Process Sheet

Customer	: CU-DAR001 Dart Helicopters Services	Drawing Name	: TUBE ASSEMBLY
Job Number	: 35294	Part Number	: D2003037
Estimate Number	: 11919	Drawing Number	: UNDER REVIEW
P.O. Number	: N/A	Project Number	: N/A
This Issue	: 10/22/2007 S.O. No. : N/A	Drawing Revision	: B
Prsht Rev.	: NC	Material	: N/A
First Issue	: N/A Type : SMALL /MED FAB	Due Date	: 11/5/2007
Previous Run	: 27296	Qty:	5 Um: Each
Written By	: 18 07.10.23		
Checked & Approved By	: 18 07.10.23		
Comment	: Est B 00.01.12 Re-format EC

DESIGN <i>JA</i>	DRAWN BY <i>SP</i>	DART AEROSPACE LTD HAWKESBURY, ONTARIO, CANADA	
CHECKED <i>JE</i>	APPROVED <i>JA</i>	DRAWING NO. D2003	REV. B SHEET 1 OF 2
DATE 99.06.08		TITLE 206 CABIN HEATER TUBE ASSEMBLIES NTS	
A	90.04.09	NEW ISSUE	
B	99.06.08	UPDATE PER TEMPLATES; ADD P/N'S; 0.025 TUBING NOW 0.035 (TSR1049)

DESIGN <i>[Signature]</i>	DRAWN BY <i>[Signature]</i>	DART AEROSPACE LTD HAWKESBURY, ONTARIO, CANADA	
CHECKED <i>[Signature]</i>	APPROVED <i>[Signature]</i>	DRAWING NO. D2003	REV. B SHEET 2 OF 2
DATE 99.06.08		TITLE 206 CABIN HEATER TUBE ASSEMBLIES NTS

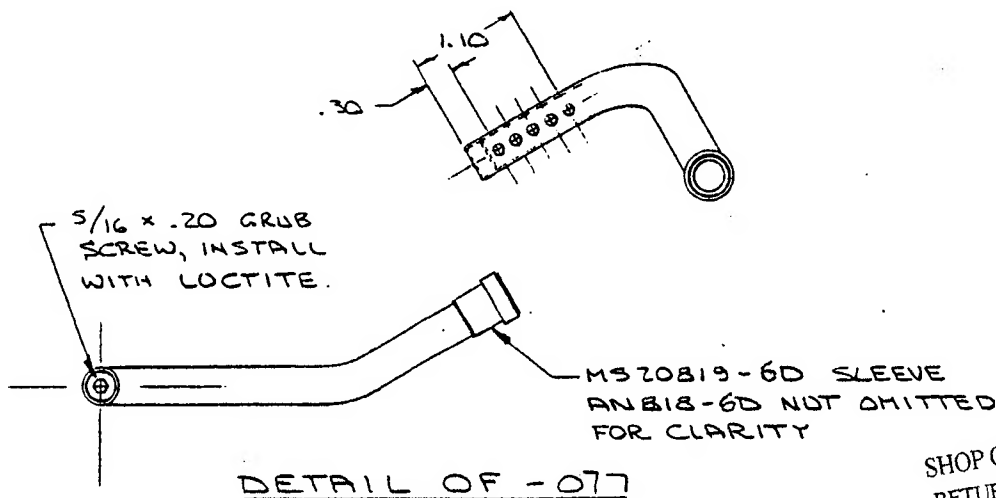
* REPORT CORRECT DIMENSIONS
TO ENG.
MAKE PER TEMPLATE. 507.10.23

Some flat lengths
and wrong
